[Docket No. FAA-2025-2546; Project Identifier AD-2025-01060-T; Amendment 39-23414; AD 2026-15-02]

Airworthiness Directives; The Boeing Company Airplanes

ACTION: Final rule.

Figure 1 to paragraph (i) – 28-AWL-05

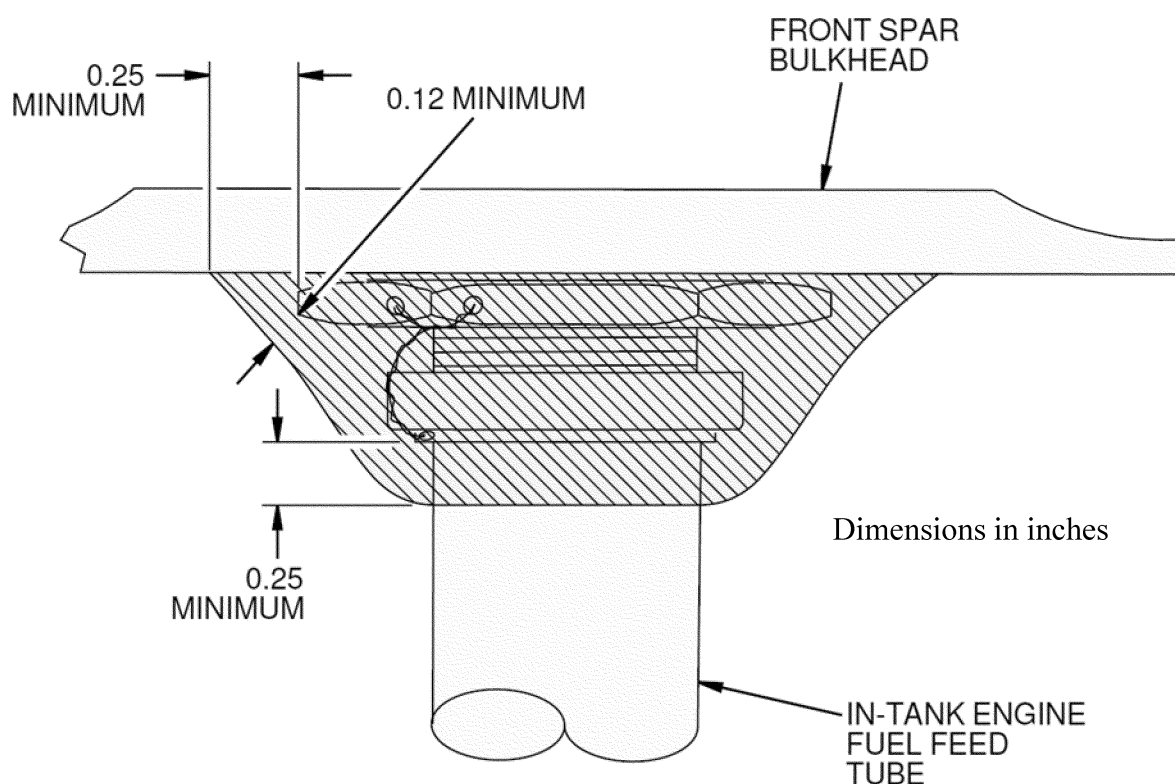
Boeing requested that the FAA revise figure 1 to paragraph (i) of the proposed AD to replace the reference to "Service Bulletin 777-28A0098" with Aircraft Maintenance Manual (AMM) 28-22-15/201 Temporary Revision, published between September 16, 2025, and September 17, 2025, or AMM 28-22-15/201 published on or after January 5, 2026, for the encapsulation procedure within the AWL. Boeing noted that standard practice is to reference AMM tasks in the description section of an AWL rather than a service bulletin.

The FAA agrees and has revised figure 1 to paragraph (i) of this AD accordingly.
